FINAL ENVIRONMENTAL IMPACT REPORT HALF MOON BAY HYATT PLACE PROJECT

State Clearinghouse No. 2018032059

City File Number: PDP 072-13

VOLUME 1 – RESPONSE TO COMMENTS DOCUMENT 1-0

Response to Commenters Letter E-1: Main Street Park

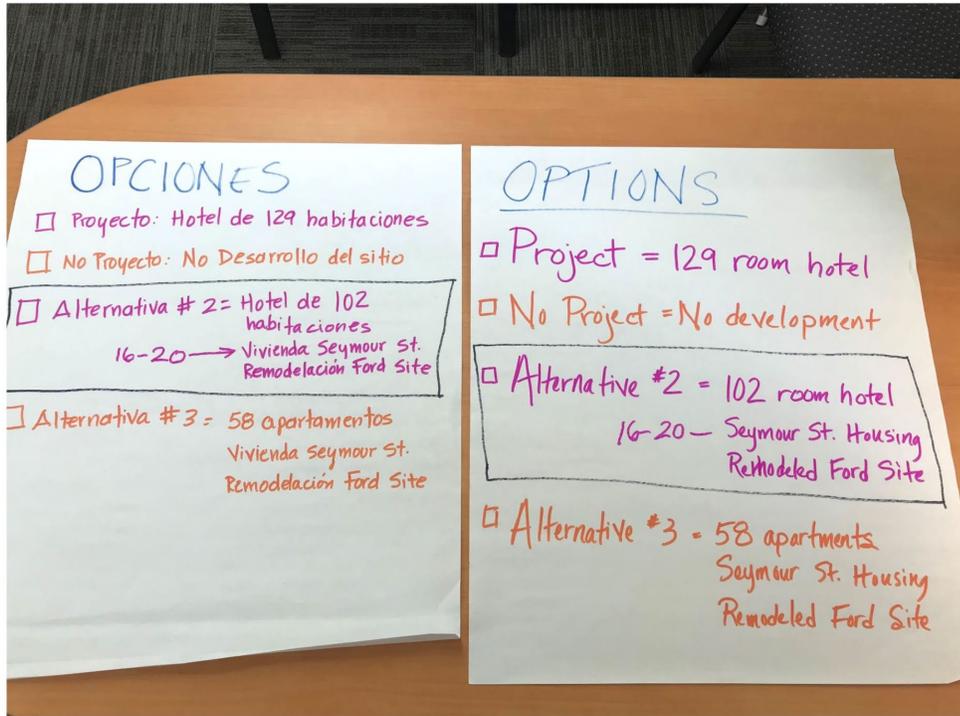
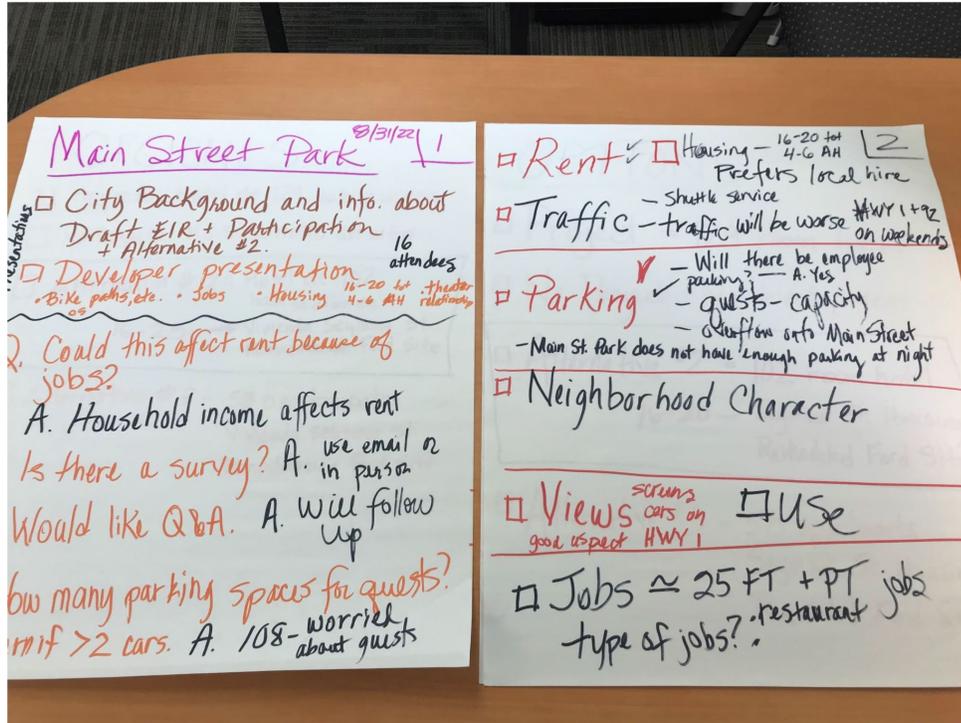
E-1.6

E-1.7

E-1.1 The comment summarizes the comments made during the Public Meeting held with Main Street Park Residents. The subsequent comments and corresponding responses reiterate topics summarized in E1.1.

Figure 5-1

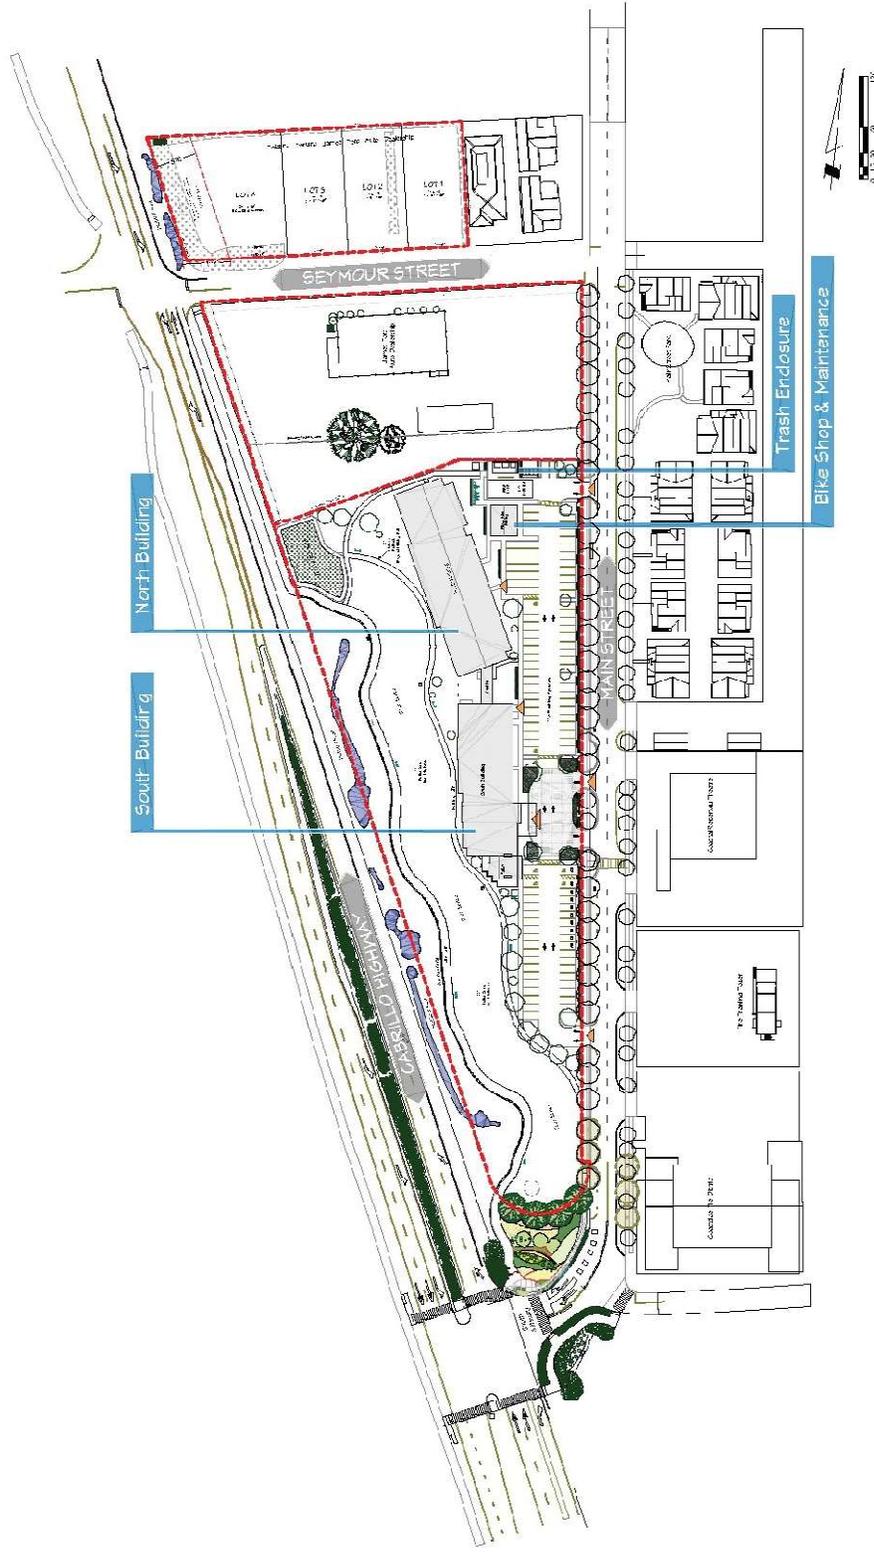
A-2.1 **1. Subdivision in Wetland Buffers.** In Alternative 2 of the draft EIR, the applicant states that if the 1.15-acre site was subdivided as proposed, it would result in a new parcel that falls within the 100-foot buffer required by the LCP for the identified seasonal wetlands. Mitigation Measure BIO-4a on page 5-31 proposes a revised subdivision to keep parcels from intruding into the 100-foot buffer. However, given the size constraints and shape of the parcel as illustrated in Figure 5-1, it is difficult to see how the subdivision would be revised to accommodate the required 100-foot buffer. Please provide more details on how this subdivision would be planned, including a preliminary site layout of the subdivision that accommodates this buffer.

A-2.1 Figure 5-1 in Draft EIR Chapter 5.0, Alternatives, includes a conceptual layout for development of the subdivision included in Alternatives 2 and 3. Following circulation of the Draft EIR, the applicant submitted revised plans to the City indicating that Alternative 2 (with revisions), is now the Proposed Project that would be considered for approval. This Proposed Project is described in the Final EIR as Modified Alternative 2. Modified Alternative 2 conforms with LCLUP Policy 6-57 because all proposed parcels can be developed without encroachment into a designated ESHA area or a required ESHA buffer. Please see Topical Response 5, Modified Alternative 2 regarding modifications to wetland buffers.
